# Value Engineering Report

## Effingham Parkway From SR 30 to Blue Jay Road Chatham and Effingham Counties CSMSL-0006-00(700); PI No. 0006700

July 6, 2016

CSMSL-0006-00(700); PI No. 0006700  
Chatham and Effingham Counties

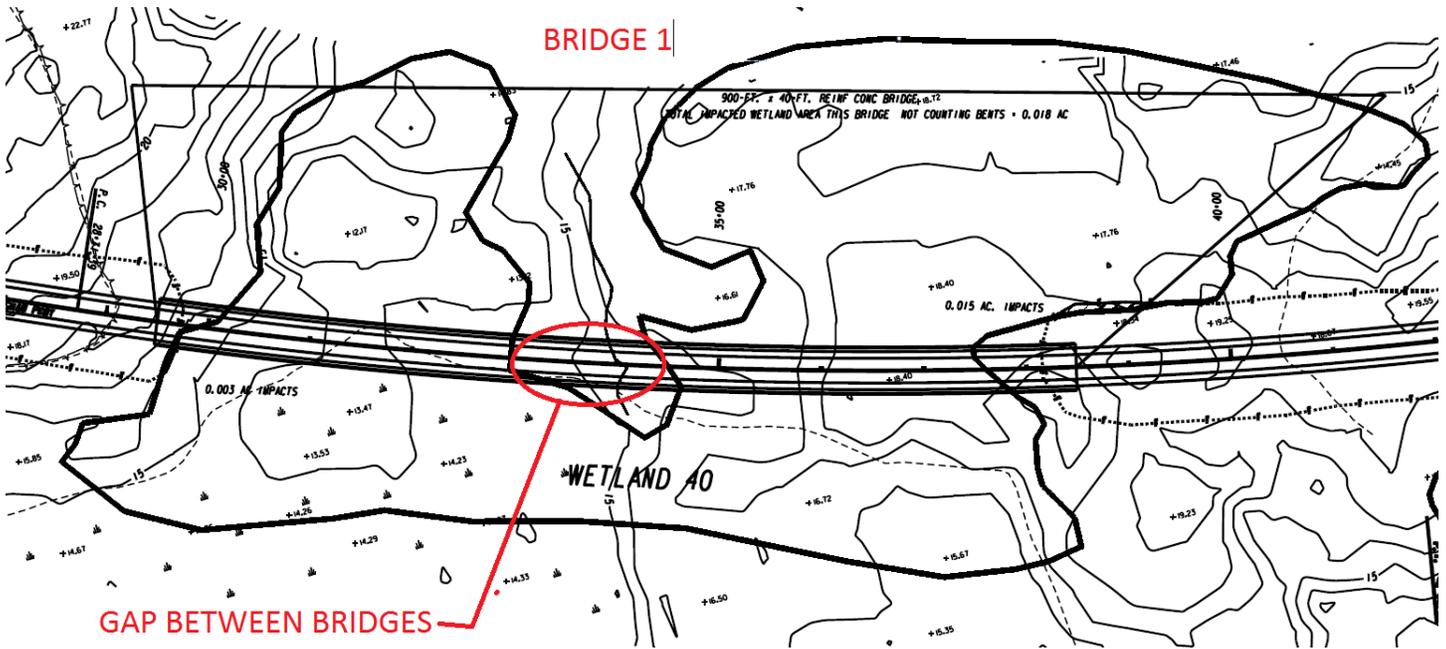
<b>SUMMARY</b>		<b>Recommendation A-7</b>		Page 1/5
Project: Effingham Parkway			Date: June 16, 2016	
<b>Recommendation:</b> Reduce the length of the long bridges; span only the wetlands				
<b>Team Member:</b> Greg Grant				
<b>Present Design Overview:</b>				
In the present design, Bridge 1 spans over Wetland #40, Bridge 2 spans over Wetland #34. Within the limits of the bridge, there is a location beneath each bridge where the wetland is discontinuous but it being spanned with bridges. This length is approximately 100 feet for Bridge 1 and 150 feet for Bridge 2.				
<b>Recommended Design Overview:</b>				
Span only the wetlands areas. Reduce the lengths of the bridges at these “non-wetland” areas				
<b>Benefits:</b> <ul style="list-style-type: none"> <li>• Shorter bridges and lower bridge cost</li> <li>• Lower bridge maintenance cost</li> </ul>			<b>Issues / Concerns:</b> <ul style="list-style-type: none"> <li>• None apparent.</li> </ul>

<b>SKETCH</b>	<b>Recommendation A-7</b>	Page 3/5
Project: Effingham Parkway		Date: June 16, 2016

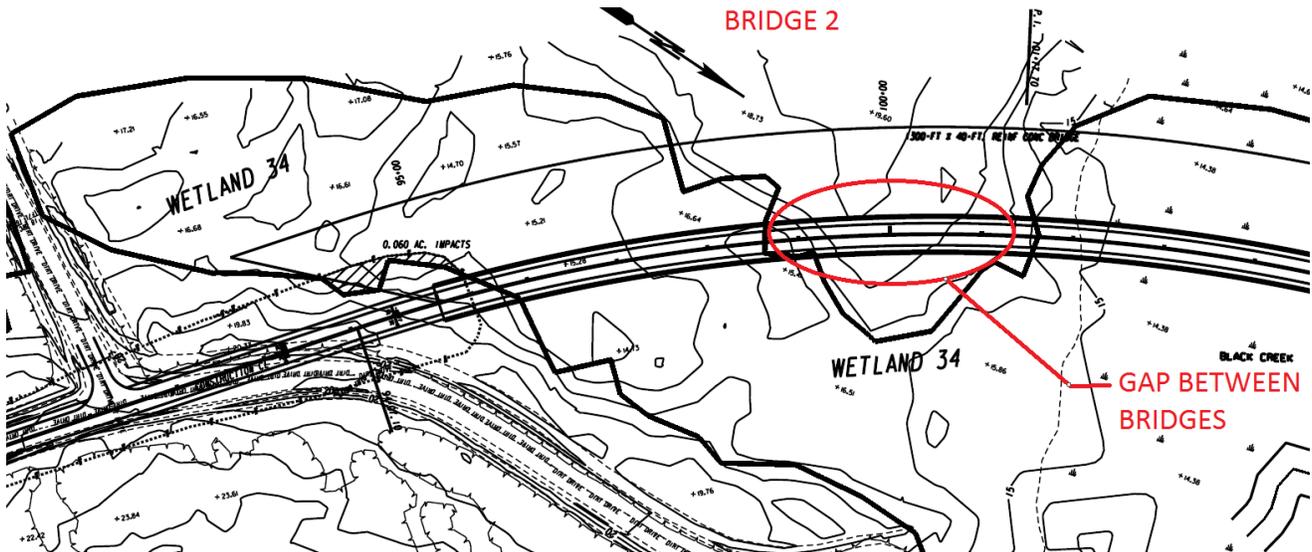
LOCATION TO BREAK UP BRIDGE 1 INTO TWO BRIDGES

Shorter bridge length – 100 feet

LOCATION TO BREAK UP BRIDGE 2 INTO TWO BRIDGES

Shorter bridge length – 150 feet

<b>SKETCH</b>	<b>Recommendation B-1</b>	Page 3/5
Project: Effingham Parkway		Date: June 16. 2016

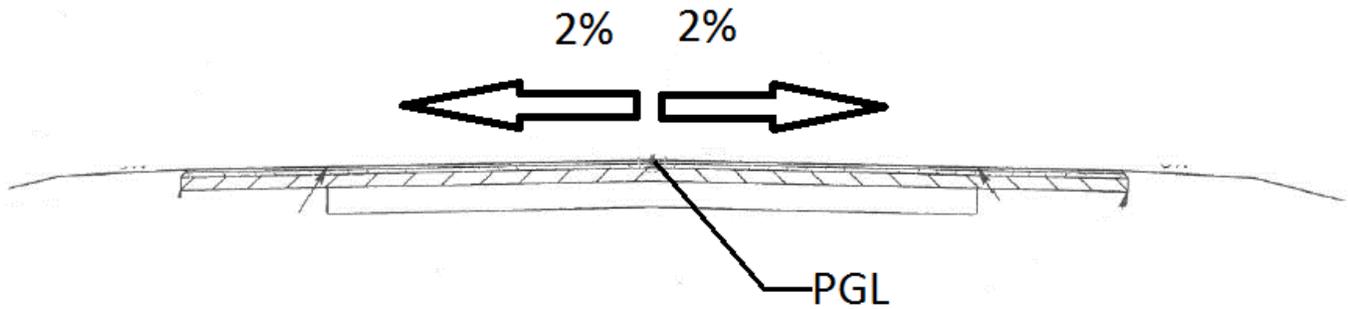
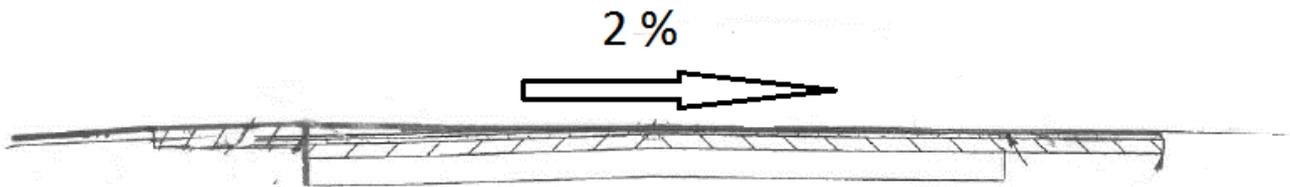
Currently Effingham Parkway is crowned at the centerline with the pavement sloping away, except in curved, superelevated areas. There is a lump sum cost of \$600,000 for MS-4 compliance for the project. By sloping the roadway in one direction for all the tangent sections, the cost of MS-4 compliance may be reduced by a factor of 1/3. Wetland impacts may also be reduced along with right of way.

By removing the crown and cross-sloping Effingham Parkway all to one side, assume a savings of 1/3 may be realized.

Areas of the project where the profile can be potentially lowered, assume 2 feet:

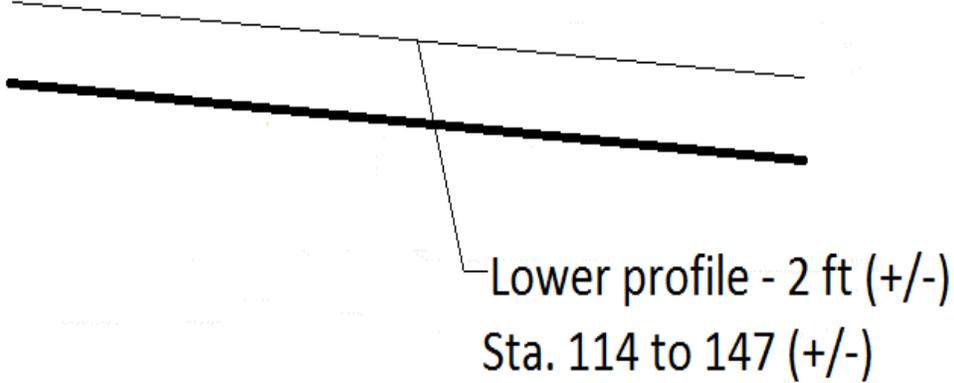
The current profile layout appears to be elevated more than necessary, based on the existing ground line and any depicted hydraulic or flooding constraints. Modifying and lowering the profile will reduce the amount of fill required to construct the roadway template and should also slightly reduce impacts, although any impact reductions are not calculated or included in this analysis.

Introducing more vertical curves with steeper grades will also help the drainage and run-off concerns with an extremely flat profile. Rather than typical grades of 0.8% or less, look to use grades of 1.5% or greater as feasible.

**Location 1**

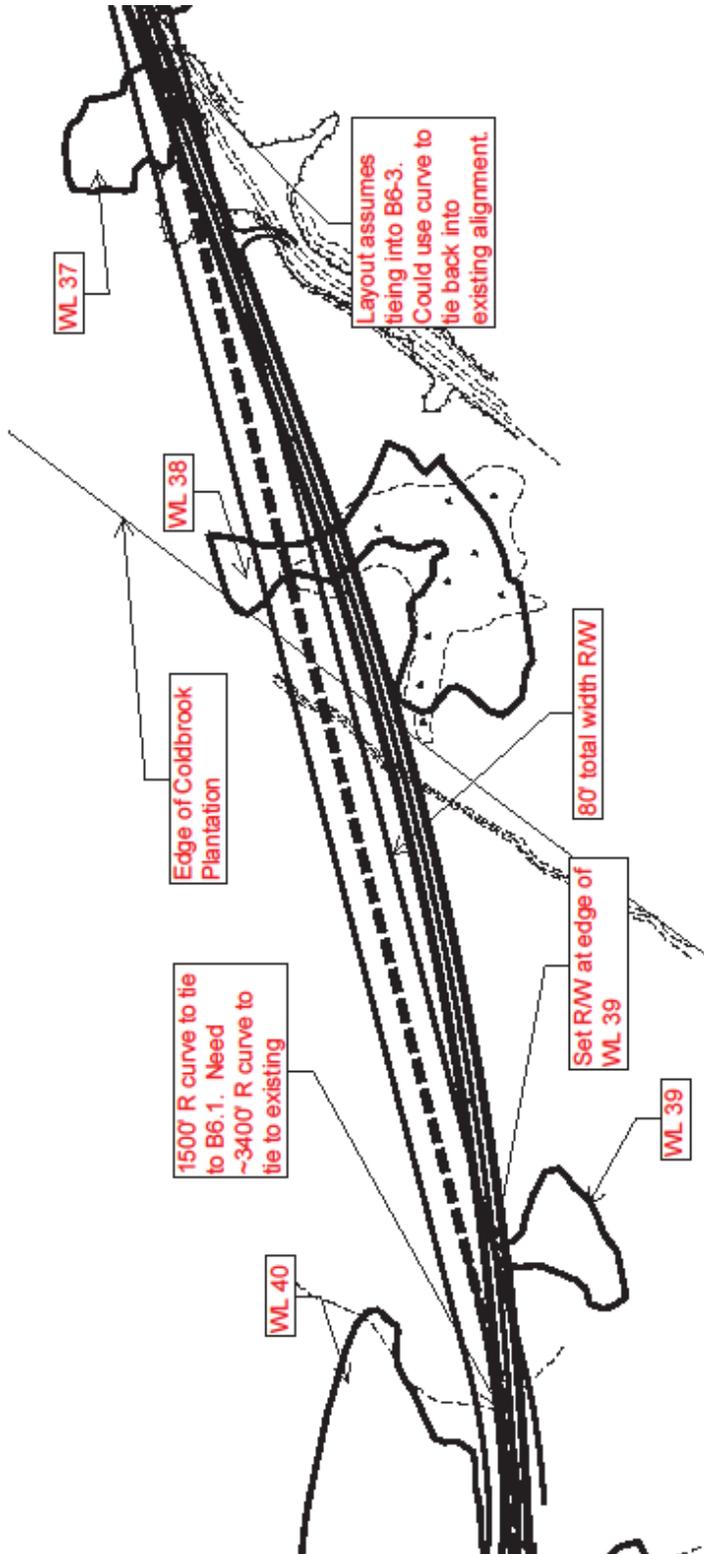
<b>SKETCH</b>	<b>Recommendation B-6.1</b>	Page 3/8
Project: Effingham Parkway		Date: June 16, 2016

**Location 2**

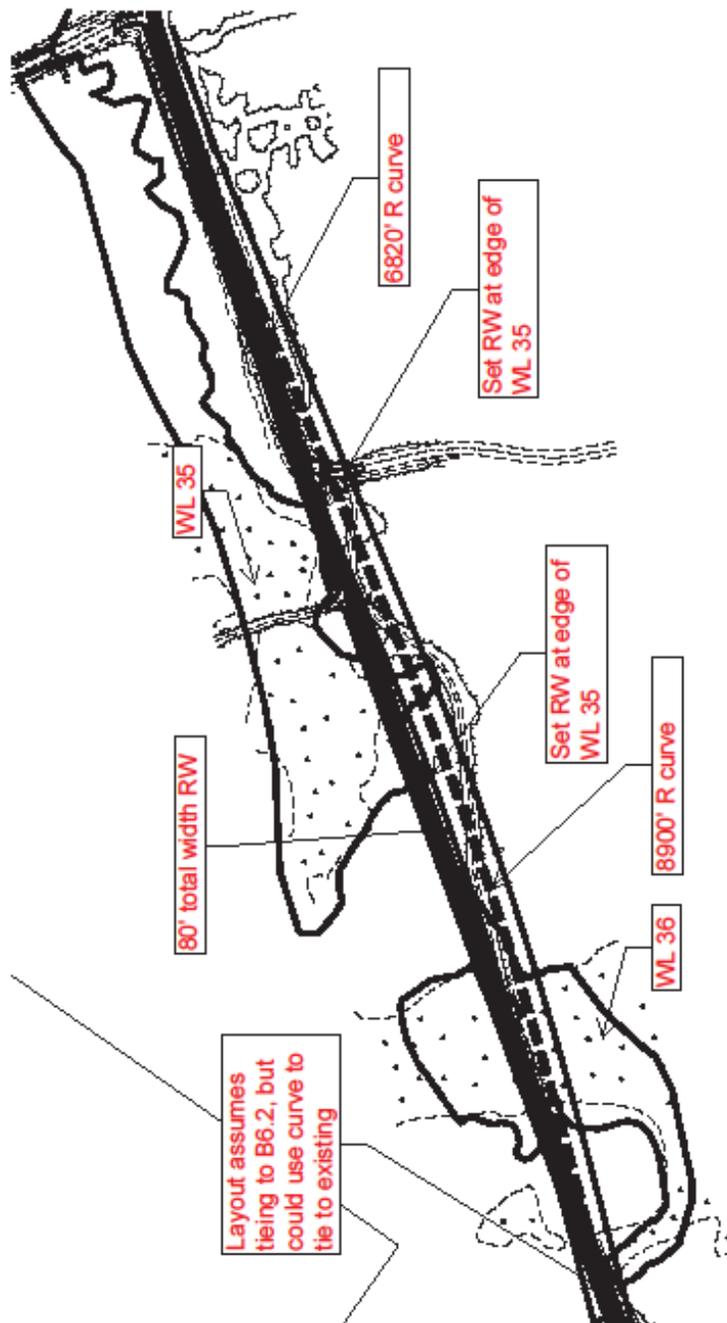
<b>SKETCH</b>	<b>Recommendation B-6.2</b>	Page 3/8
Project: Effingham Parkway		Date: June 16, 2016

**Location 3**

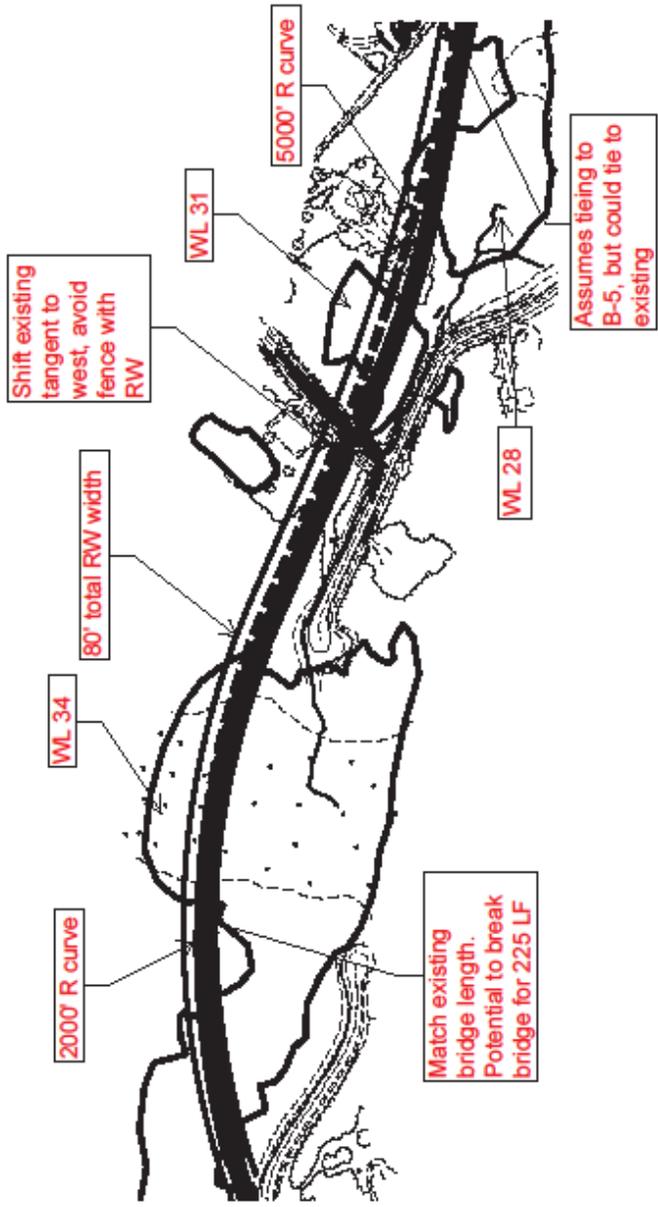
<b>SKETCH</b>	<b>Recommendation B-6.3</b>	Page 4/8
Project: Effingham Parkway		Date: June 16, 2016

**Location 4**

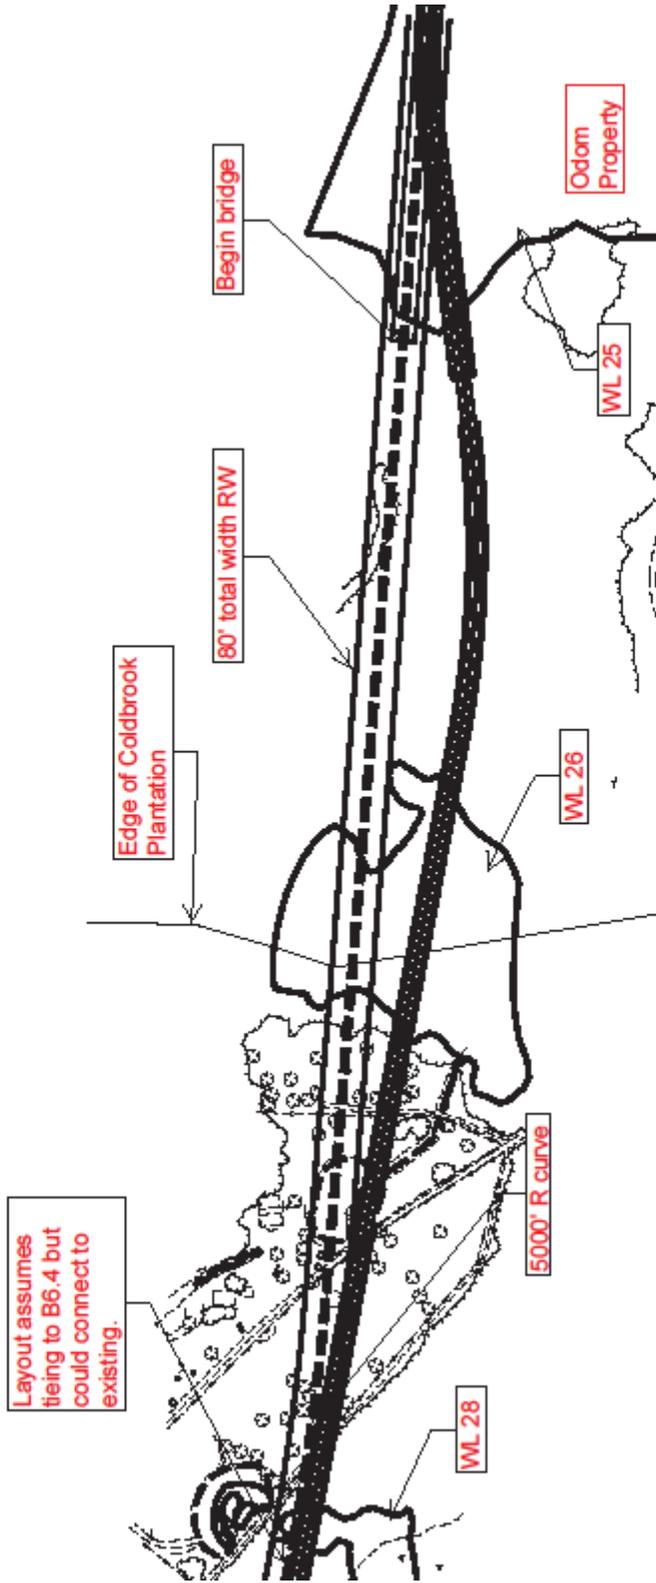
<b>SKETCH</b>	<b>Recommendation B-6.4</b>	Page 5/8
<b>Project:</b> Effingham Parkway		<b>Date:</b> June 16, 2016

**Location 5**

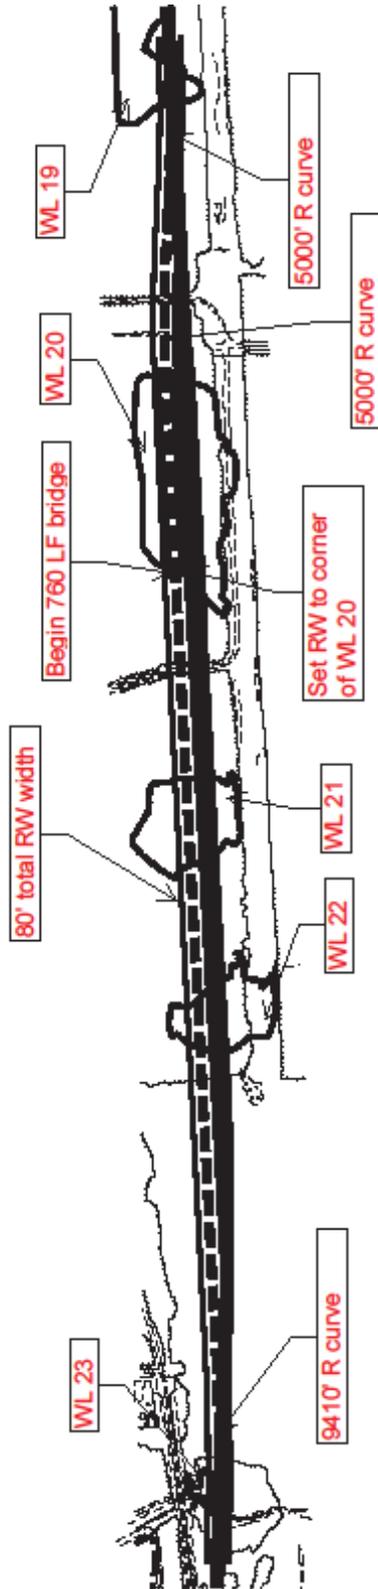
<b>SKETCH</b>	<b>Recommendation B-6.5</b>	Page 6/8
Project: Effingham Parkway		Date: June 16, 2016

<b>SKETCH</b>	<b>Recommendation B-8</b>	Page 3/5
Project: Effingham Parkway		Date: June 16, 2016

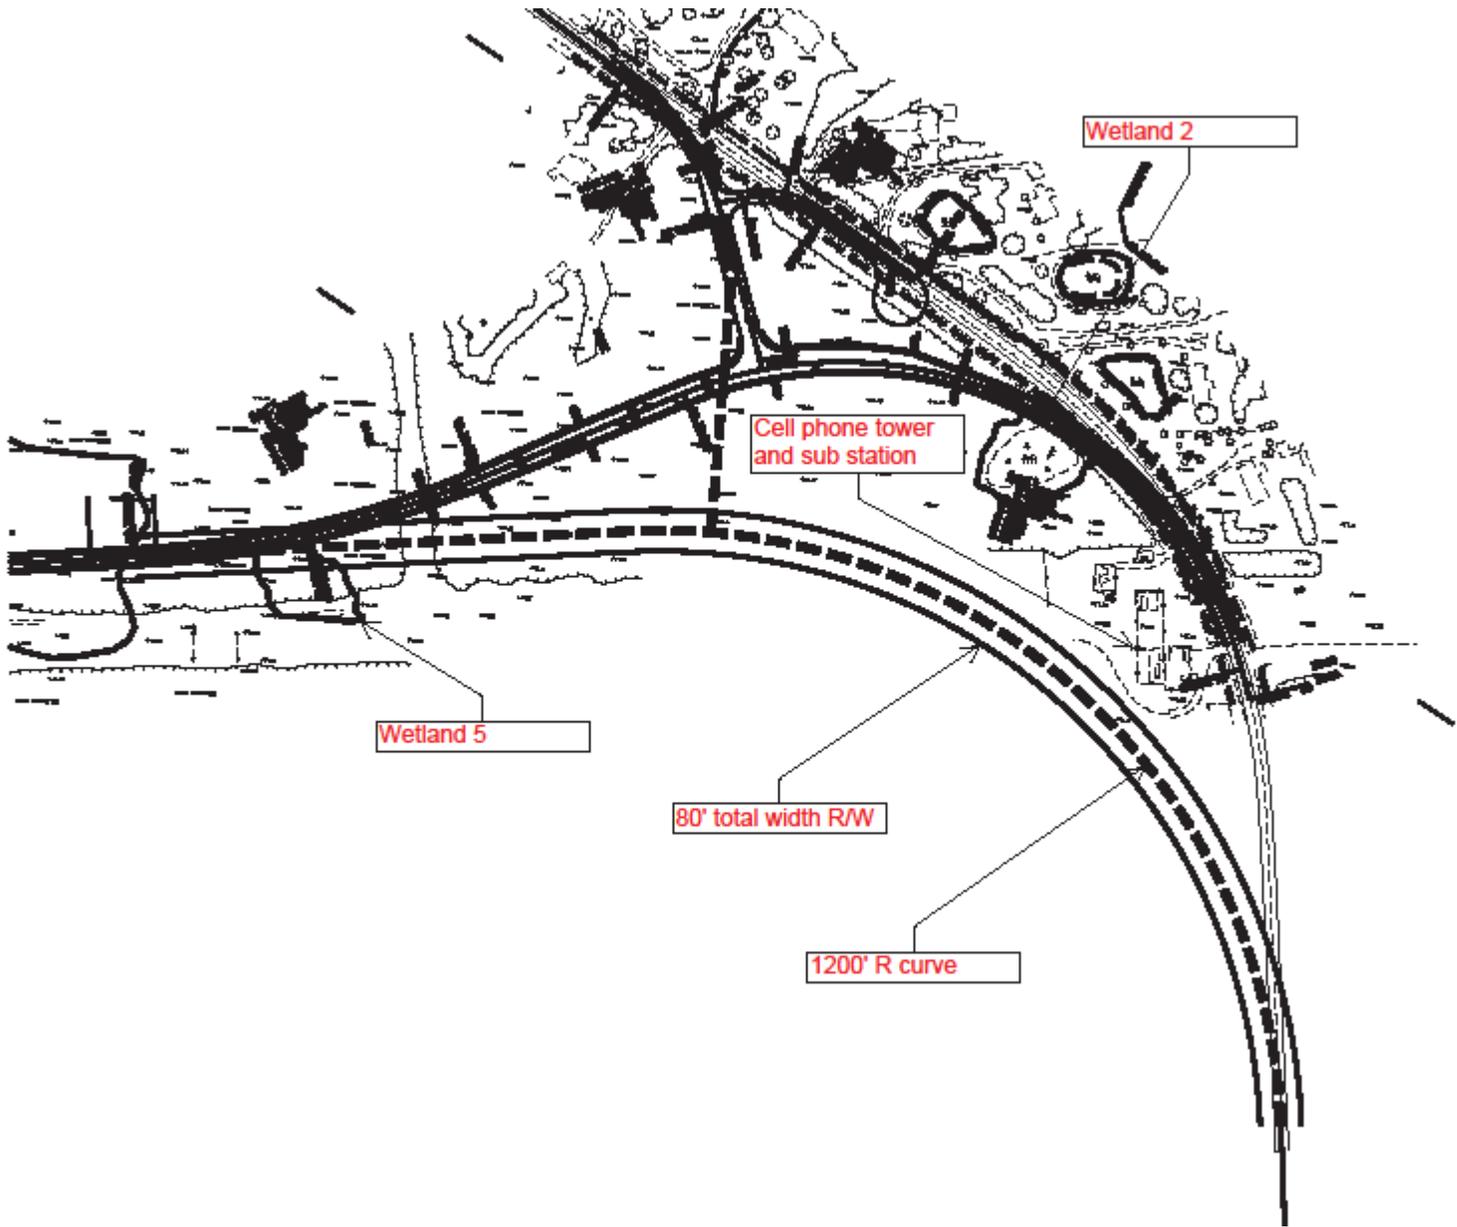
The proposed length of the new alignment, as well as the necessary extension of the Blue Jay Rd connector is longer than the existing design however it does provide the continuous design speed of 55 mph. In addition the parcel access to several properties, including Wheeler and Dowd, will need to be examined, but this can likely be handled from the existing cul-de-sac. The proposed property tie-ins will be better aligned and addressed as part of this recommendation, using the existing Blue Jay Road.
